NASA/TM-2005-213792/Version 1.0
NESC-RP-05-82/05-010-E

NESC Peer-Review of the Flight Rationale for Expected Debris Report

July 7, 2005

Figure 9.2-1. Flow of Data Defining Environment, Modeling Damage, Analyzing Capability and Culminating in the “Damage Tolerance Threshold Map”

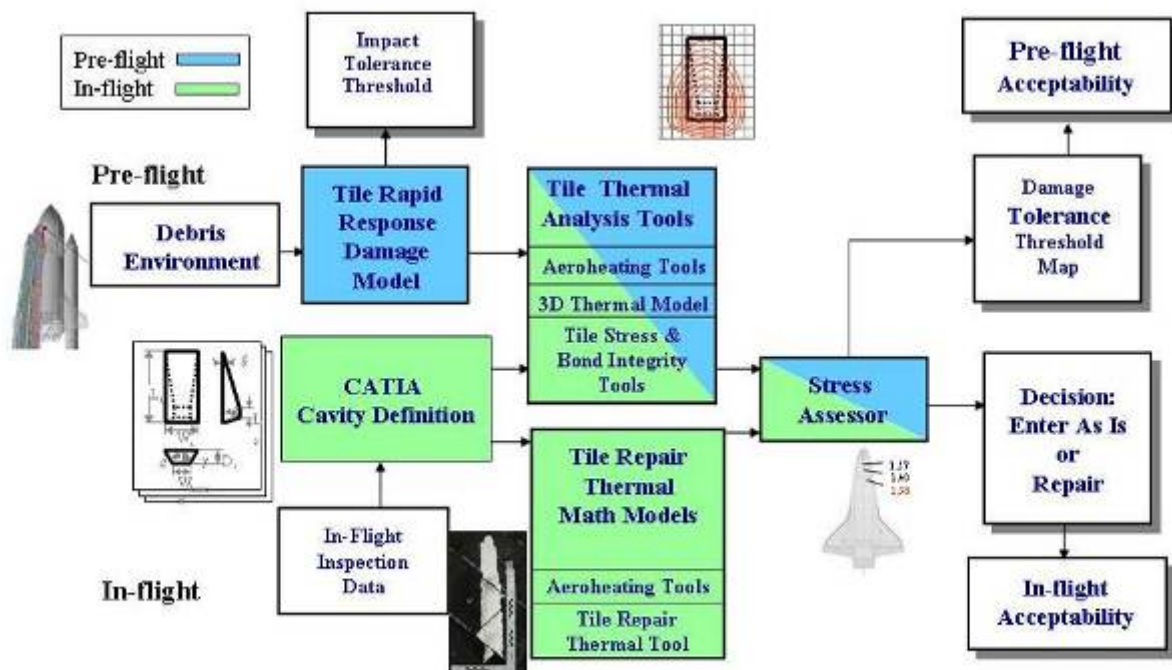
1. The limitations and gaps in the development of the damage map, and its use in the flight rationale, are driven by the limitations and gaps of the individual tools. These are discussed in detail in [Appendix C](#).

Figure 10.1-3. STS-100 Ice/Frost Ramps 5-9

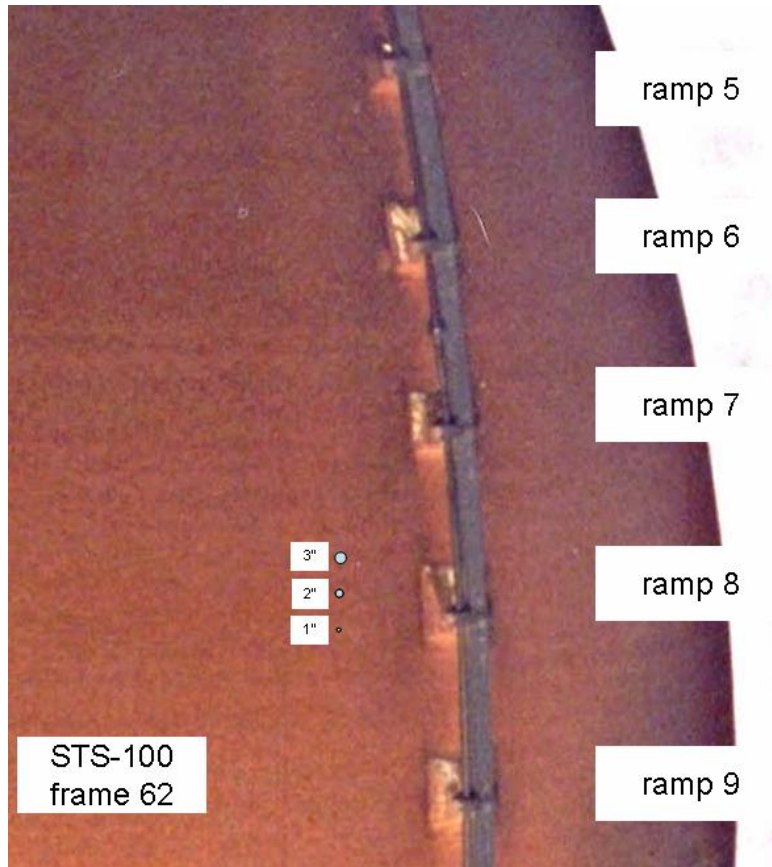
The Aerospace Corporation Monte Carlo analysis identified the most likely contributor to foam-induced damage as the ice/frost ramps. However, the model predicted divoting at a much higher rate than had been previously documented from the ET separation photographs (only a single 3-4 inch divot was identified in 161 post-ET-82 ramps that were imaged). Therefore, a review of the ET separation photos for ISS flights was performed by the NESC. Figure 10.1-3 shows the foam loss from ramps 5-9 for STS-100. The figure contains circles scaled to 1, 2 and 3 inch diameter for size comparison. The photograph shows evidence of foam loss in the size range predicted by the Aerospace analysis. Ramps 6 and 7 each show multiple instances of foam loss.

In addition to the single large ice/frost ramp divot (out of 161 ramps imaged) previously documented, the separation photos of ISS missions show fairly frequent small (on the order of 1 to 3 inch diameter) losses of foam from the middle LO₂ ice/frost ramps. The rate of loss at these locations is in line with that predicted by the Aerospace Corporation in their Monte Carlo analysis. However, because the photographs show no foam loss from ramps lower on the LO₂ tank and on the intertank, the overall probability of not exceeding the allowable impact loads on tile is lower than that predicted by the Monte Carlo analysis. In a first order sense, the Aerospace results for tile impacts from ice/frost ramp divots are at most an order of magnitude conservative.
